Access Compliance Report Public Rights-of-Way (Curb Ramps)

Main Street: LAURIE_LN		Cross Street: PROSPECT_AVE		Location:	NW
ADA ID: RPAT211018144712	Ramp Type: Type 7 - Directional 2	Initial Pass/Fail: Fail	Overall Compliance: No	Severity Score:	15
Codes/Mitigation Info/Possible Solution			Field Measurements/Component Compliance

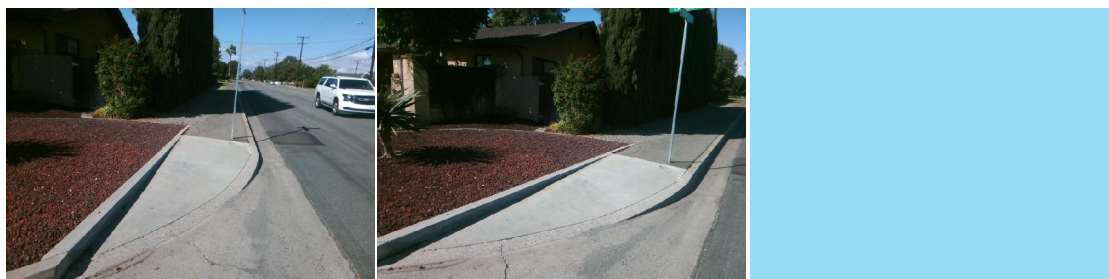
R204.3, R304.5.3, STD 1115

Compliance	Description	Data	Compliance	Description	Data
N/A	Ramp Length (in)	153	N/A	Flare Type LT	
Yes	Ramp Width (in)	48			N/A
Yes	Ramp Run Slope (%)	4.5	N/A	Flare Slope LT (%)	N/A
No	Ramp Cross Slope (%)	6.8	N/A	Flare Traversable LT	N/A
N/A	Grade Break	N/A	N/A	Flare Type RT	
N/A	Grade Break Slope (%)	N/A			N/A
N/A	Grade Break Cross Slope (%)	N/A	N/A	Flare Slope RT (%)	N/A
	Addl Para Ramp Left?	No	N/A	Flare Traversable RT	N/A
	Addl Para Ramp Right?	No	N/A	DWS Provided	N/A
N/A	Landing Present	N/A	N/A	DWS Contrast	N/A
N/A	Landing Length (in)	N/A	N/A	DWS Length (in)	N/A
N/A	Landing Width (in)	N/A	N/A	DWS Full Width	N/A
N/A	Landing Run Slope (%)	N/A		DWS Offset Type	N/A
N/A	Landing Cross Slope (%)	N/A	N/A	DWS Left Offset (in)	N/A
N/A	Landing Movement Obstructed?	N/A	N/A	DWS Right Offset (in)	N/A
	Landing Movement Type	N/A			
N/A	Landing Shared	N/A			
N/A	Marked Crosswalk 1	No	N/A	Clear Space	N/A
	Crossing 1 Direction	S	N/A	Clear Space To Crosswalk (in)	N/A

Remove & Replace Entire Ramp.
